West Elk Mining Plan Modification Final Environmental Assessment

- Appendix A Plan to Address a Methane Flare System
- Appendix B Lease, Lease Modification, and CDRMS Permit Stipulations
- Appendix C Response to Comments on EA

Appendix A Plan to Address a Methane Flare System

Figure 2. Existing Approved Mine Plan

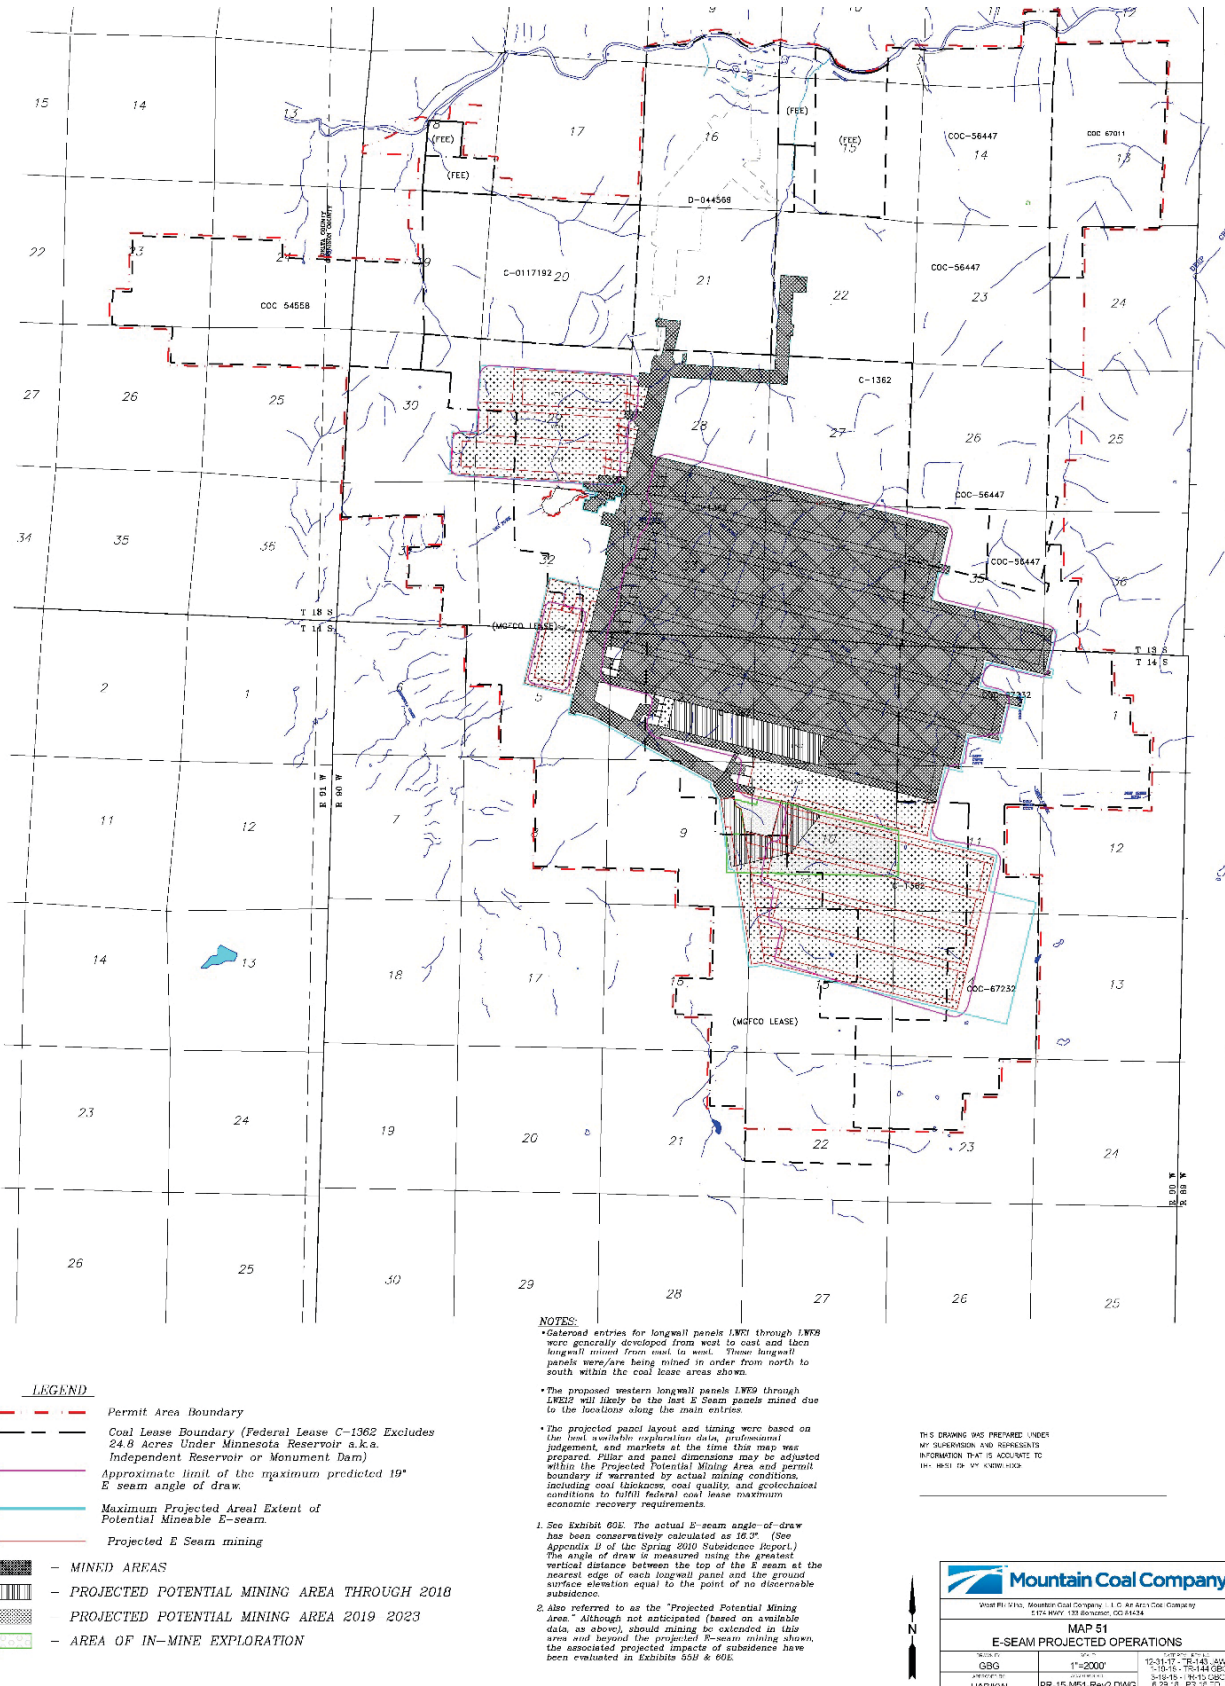
| No. | Commenter | Comment | Response | EA Changes |
|-----|--|---|--|--|
| 1. | Michael Drysdale for Mountain Coal Company | <p>Figure 2 in the EA depicts and is titled "Existing Approved Mine Plan." The Figure shows "Map 51 — E Seam Projected Operations"</p> <p>from Mountain Coal's Permit Revision 15 approved by the State of Colorado. As such, Figure 2 is an accurate depiction of what it purports to be. However, because Map 51 was prepared in 2018, and shows projected future mining, the depiction of what mining has occurred and will occur is out of date. This is clear from the Legend of Map 51 and when read in conjunction with the text of the EA, but could be confusing to some readers. Consequently, Mountain Coal recommends that the final EA add text that explains the depiction of current and future mining on Figure 2 was correct as of the date Figure 2 was produced. A suggested revised paragraph would read as follows:</p> <p>The West Elk Mine has been in operation since 1981 and encompasses about 13,358.4 acres of federal coal leases and 6,496.5 acres of fee coal lands (USES, 2017a), including the lease expansion areas. MCC is in the process of mining ESeam reserves in previously permitted portions of COC-1362 and COC-67232 leases (Figure 2) (<u>Figure 2 depicts the state of current and projected mining as of the State of Colorado's consideration of Permit Revision 15. Mining since Figure 2 was prepared is described below</u>). Prior to the Judge's Order on November 8, 2019, MCC mined approximately 330,800 tons from the northernmost modified portion of lease COC-1362 from extended longwall panel E8 per the approved Technical Revision No. 143 (TR-143). Per approved Technical Revision No. 144 (TR-144), about 32,600 tons were mined from modified federal lease COC-1362 by development exploration of longwall panel SS1. No coal was mined from modified lease COC-67232 under either TR-143 or TR-144. <u>As of the date of this EA, mining of longwall panel E8 is nearly complete.</u></p> | OSMRE agrees this revision is appropriate. | These revisions have been made in Section 2.2 on page 7. |

Figure 5. Water Resources

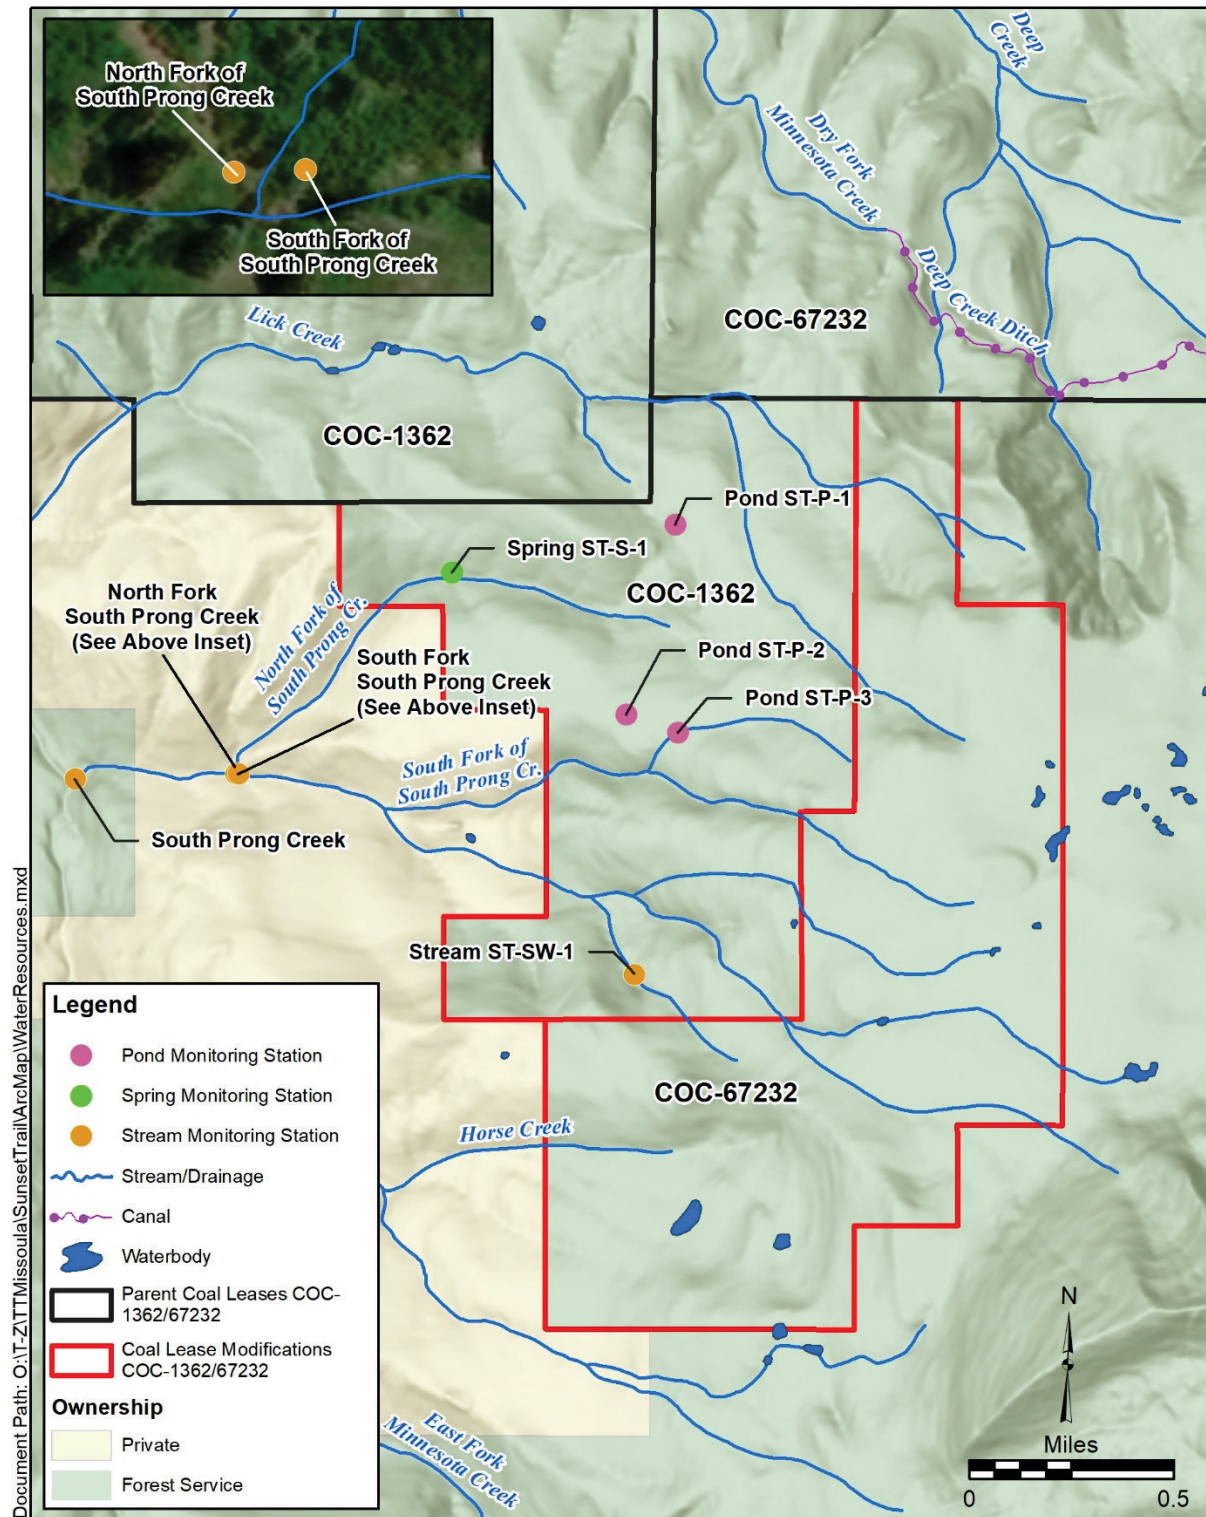
<table><tr> <th data-bbox="537 586 751 618">Statement</th> <th data-bbox="751 586 972 618">Should Say</th> <th data-bbox="972 586 1188 618">Page</th> </tr><tr> <td data-bbox="537 878 751 987">Location of Stream Monitoring Station ST-SW-1 on Figure 5</td> <td data-bbox="751 878 972 987">The location appears to be mis-identified on the map (as depicted is not intersecting a marked stream), and may need to be corrected</td> <td data-bbox="972 878 1188 987">Figure 5, page 37.</td> </tr></table>
